Product / Process Change Notification (PCN)

PCN Number: PCN_ConDSUB_20241208

Affected Series: WR-DSUB

Affected Order Codes: 61800925123

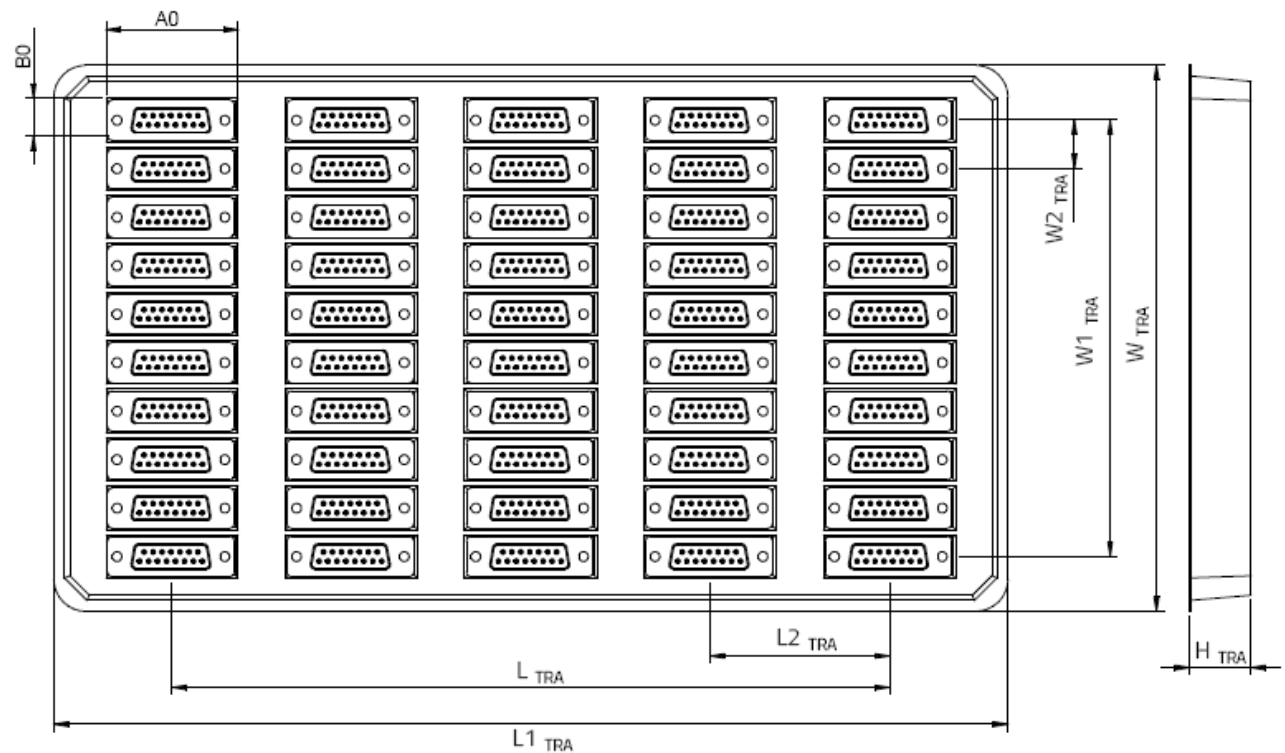
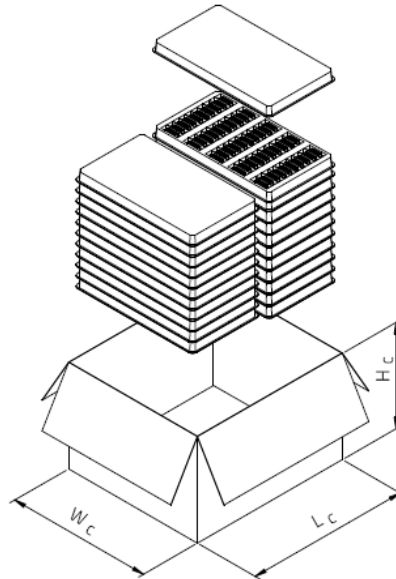
Before change: Tube packaging

After change: Tray packaging

(in mm)	A0	B0	LTRA	L1TRA	L2TRA	WTRA	W1TRA	W2TRA	HTRA
61800925123	19.4	10.7	122.6	186	30.65	174	123.3	13.7	14.35

Lc	Wc	Hc	SPQ	Qty / carton
Before	650	140	125	48	960
After	360	200	300	50	1500
